SAFETY EVALUATION BY THE OFFICE OF NEW REACTORS
LICENSING TOPICAL REPORT MUAP-07007-P, REVISION 6
“HUMAN SYSTEM INTERFACE SYSTEM DESCRIPTION AND
HUMAN FACTORS ENGINEERING PROCESS”
MITSUBISHI HEAVY INDUSTRIES, LTD.

SAFETY EVALUATION BY THE OFFICE OF NEW REACTORS

LICENSING TOPICAL REPORT MUAP-07007-P (REVISION 6)

“HUMAN SYSTEM INTERFACE SYSTEM DESCRIPTION AND
HUMAN FACTORS ENGINEERING PROCESS”

Figure 1: Soft Switch

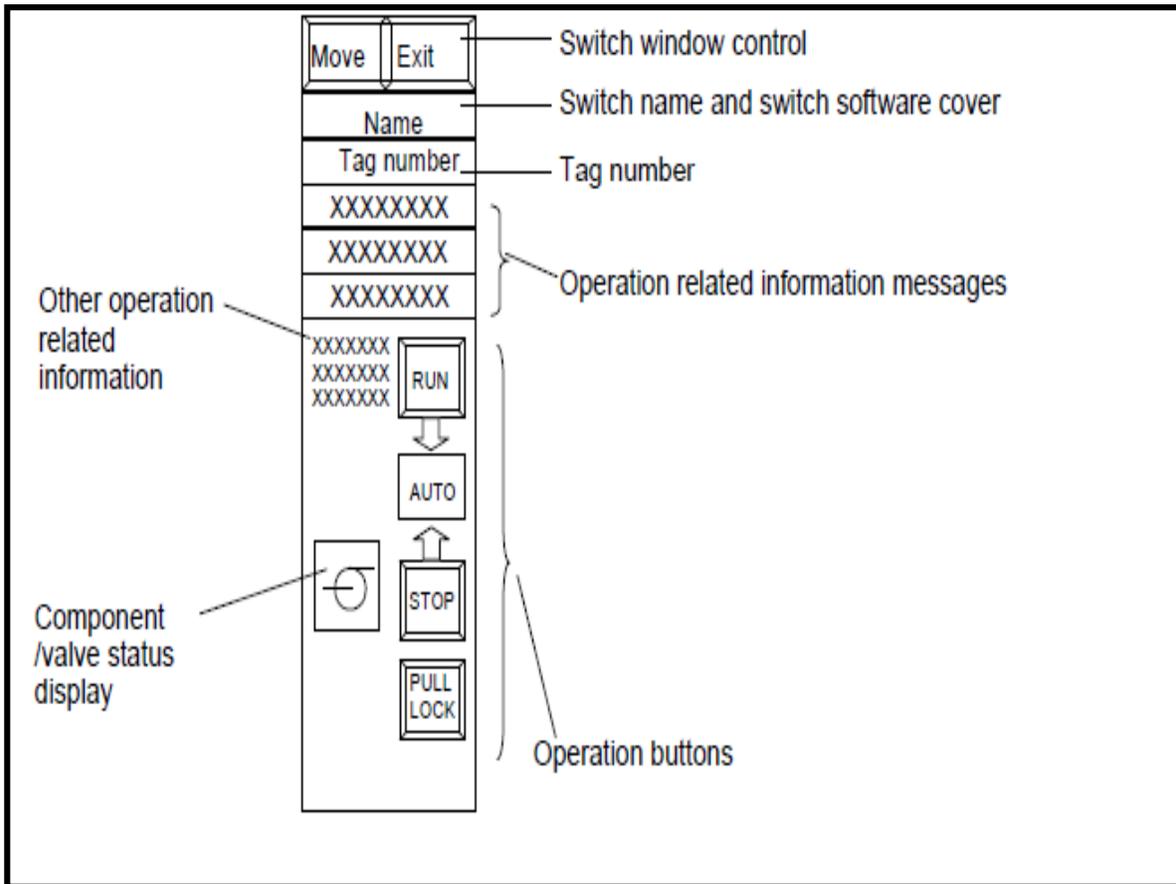
Figures 1, "Soft Switch," and 2, "Soft Controller," of a typical soft switch and a soft controller are provided below to help illustrate the HFE design that has been incorporated in each.

Soft control input is made by way of discrete-adjustment interfaces usually in the form of a button (i.e., start/stop, open close for a soft switch an increase/decrease buttons for controller settings). Discrete versus continuous-adjustment interfaces are preferred because the settings can be established by fairly gross movements. For controllers, setpoints can also be input using a numeric keypad function. Immediate feedback on the control activity is provided via the component status icons and in the case of controllers the bar graph display of target, process and deviation values. Since controllers provide continuous control functions they can be difficult to use due to digital system processing delay. To avoid the stress, confusion, and overshoot often caused by typical manual demand feedback indication delay, the soft control system accepts the demand signal, displays the target point in the manual value bar and sends the target values to the controller. A discrepancy between the demanded value and the value in the controller is easily seen by the operator.
